Manual 14B Updates for Batter Dispatch

Summary of Changes

Lead Engineer, Transmission Planning – West
Planning Committee

February 3, 2026

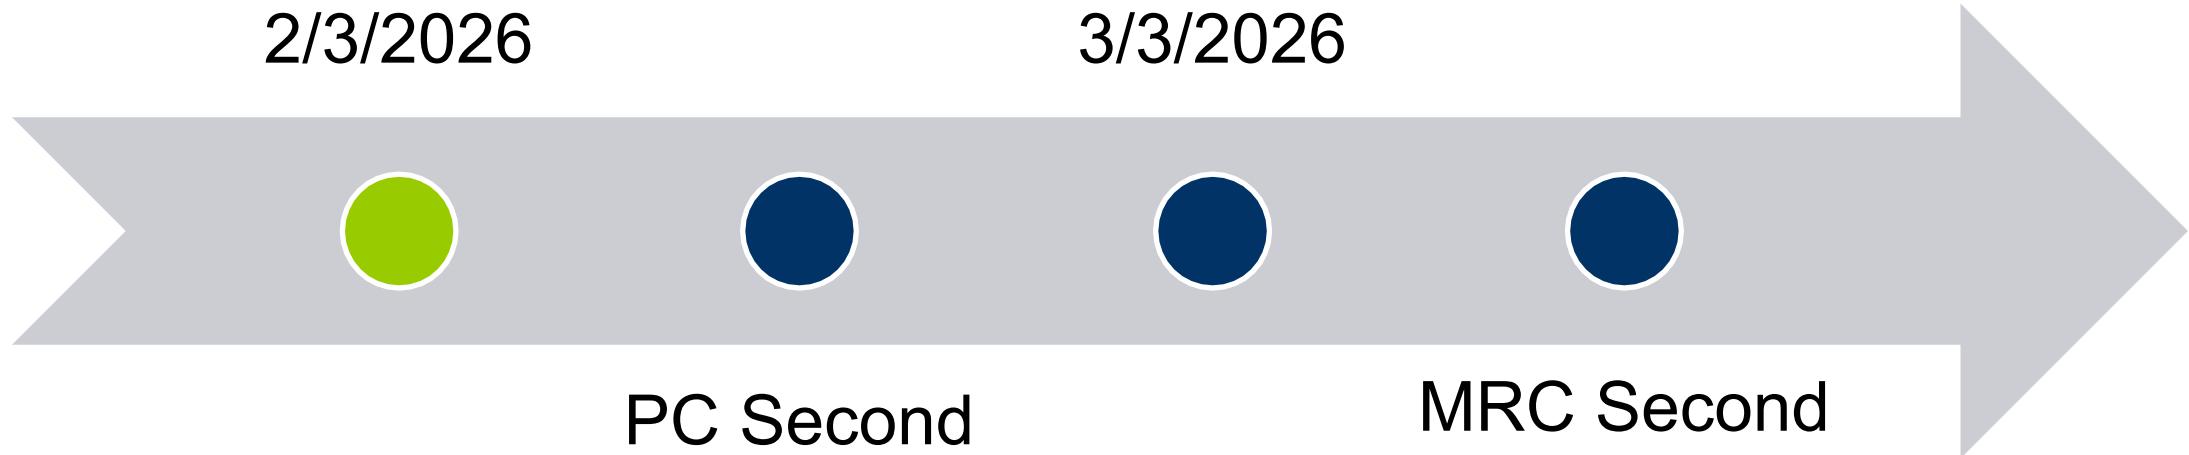
- The existing block dispatch methodology in planning manual 14B models batteries offline in the planning base case, but the units are available to be ramped in the generator deliverability study.
- Allowing the batteries to be dispatched in the RTEP base cases will increase available generation (tied to actual projects part of the interconnection queue).
 - This change provides better alignment with RTEP planning assumptions, state policies and queued projects part of PJM interconnection process(es).
